PLANNING AND ZONING BOARD STAFF REPORT

Lenny's Car Wash

Meeting	File No.	Application Type
August 17, 2026	PZ-000360-2025 (Site Plan) PZ-000359-2025 (Conditional Use)	Level 4 Site Plan & Conditional Use
Property Owner / Applicant		Authorized Agent
Equitable Reof, LLC		Jeffrey Costello, AICP, FRA-RP JC Planning Solutions

Proposed Landscape Plan

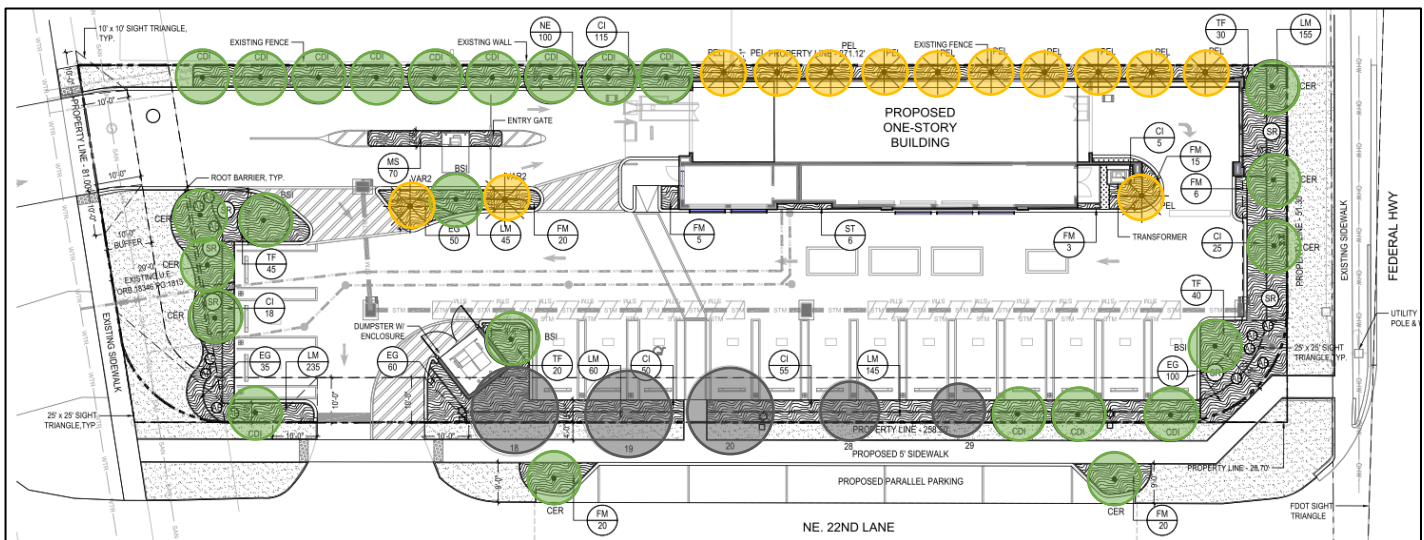
The proposal includes the removal of 12 trees and 12 palms; the removed trees meet the mitigation standards pursuant to LDR Section 4.6.19, with replacement on a one-to-one or Diameter at Breast Height (DBH) basis depending on the condition rating of each tree/palm. Five existing trees will remain, shown in grey below.

The proposal includes 25 new trees, shown in green, and 13 new palms, shown in orange. The canopy trees are primarily along the property line, with some located on the parking islands including along the proposed parallel parking spaces along NE 22nd Lane. Although no trees are proposed near the existing sidewalks on Old Dixie and North Federal Highway due to the existing utility and overhead lines, the proposed sidewalk along NE 22nd Lane is shaded by both existing trees to remain and new canopy trees. The proposal also includes new shrubs and groundcovers throughout the site.

Proposed Southwest Elevation

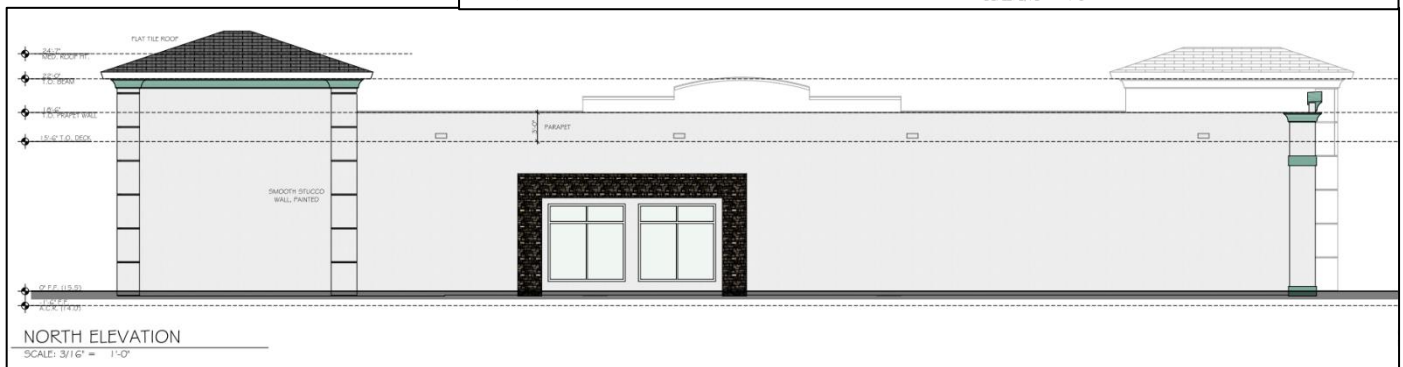
The proposed elevations have been reviewed for compliance with Section 4.6.18, Architectural Standards. The building's design incorporates a neutral color palette specifically white for the main façade and teal for the trim, varied materials including stucco and stone, and a pitched grey tile roofline, making it generally compatible with the surrounding commercial and residential development.

The east elevation fronting North Federal Highway features window openings to the car wash tunnel. The façade adjacent to the north property includes an opening into the car wash tunnel, stone material around the opening similar to the south façade, and minimal relief to the stucco to break up the blank façade; however, the overall design on the north façade is lacking the same quality of design proposed on the other facades and is viewed as the ‘rear of the building’ with minimal design although fronting an adjacent property. The façade has an opportunity to incorporate additional design elements, possibly a mural, to break up the large expanse of blank stucco.

Proposed One-Way Route

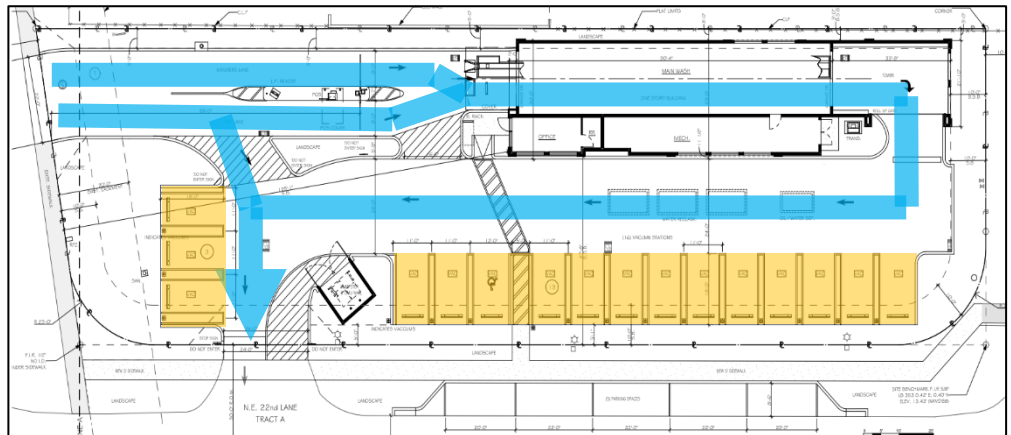
The proposed parking spaces are perpendicular, which require a 24-foot, two-way drive aisle. The project proposes to maintain the required 24-foot drive aisle, but to allow one-way traffic flow. The overall site is designed for one-way circulation, entering from Old Dixie Highway and exiting onto NE 22nd Lane. The entrance splits into two service lanes leading to pay gates before the car wash tunnel. The car wash offers a membership plan and a one-time guest option, with menu boards available to select service levels. If customers no longer want to continue through the tunnel, there are two opportunities before and after the gate to exit the line. Once customers exit the tunnel, there is an opportunity to park in one of the 16 spaces to utilize the vacuums or continue to the exit on NE 22nd Lane.

The proposed 24-foot drive aisle meets the required maneuvering width, and the plans identify a defined one-way route, directional signage, and service-vehicle maneuvering route. Employees are limited to entering the site from Old Dixie Highway turning south prior to the arm gate with the only available parking being the three located to the west. Service vehicles will also maneuver the same route as the employees, collecting waste prior to exiting the site on NE 22nd Lane. The relief applies to an internal drive aisle located after the car wash tunnel and does not alter the public right-of-way or principal vehicle queue. No direct adverse effect on the neighboring area, significant reduction in public facilities, or special privilege has been identified based on the site-specific configuration

The remaining issue is whether the proposed one-way circulation next to the perpendicular parking spaces would create an unsafe situation. Vehicles backing from the vacuum spaces to the west would share the aisle with employees and service-vehicle movements. The aisle meets the required width, but the submitted information does not establish that the proposed one-way pattern will not create an unsafe situation. Two-way circulation within the parking area may be feasible on the site after ensuring there is sufficient six-foot

maneuvering area for the dead-end bay; the two-way circulation would offer an alternative entrance from NE 22nd Lane. The Board should consider whether the one-way traffic flow will adversely affect internal circulation or safety, or whether the proposed operational maneuvering route is functional for the site.

Proposed Reduced Stacking Distance

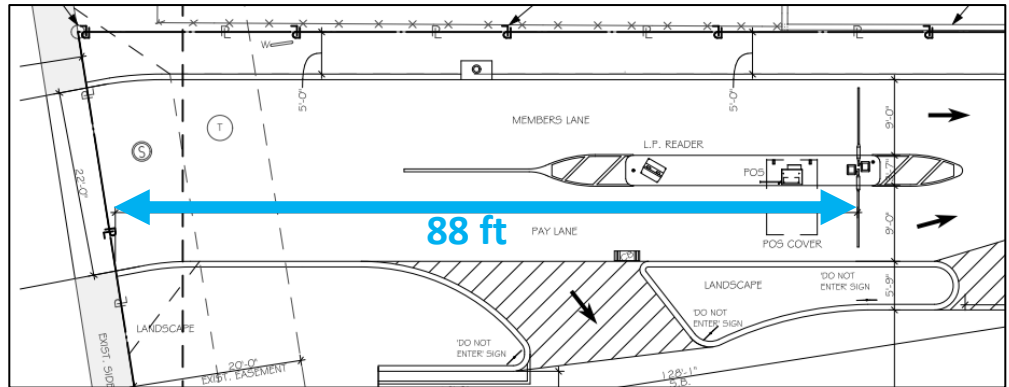
The Applicant is requesting to reduce the required 100-foot minimum stacking distance from the property line to allow a stacking distance of 88 feet for the car wash access gate. Pursuant to LDR Section 4.6.9(D)(5), a reduction to the minimum required stacking distance may be requested when supported by a traffic study and justification statement addressing access into the site and efforts to diminish the impact of queuing on the public right-of-way and the City Engineer shall provide a written determination regarding the request to reduce the stacking distance. The City Engineer has reviewed and approved the reduced stacking distance.
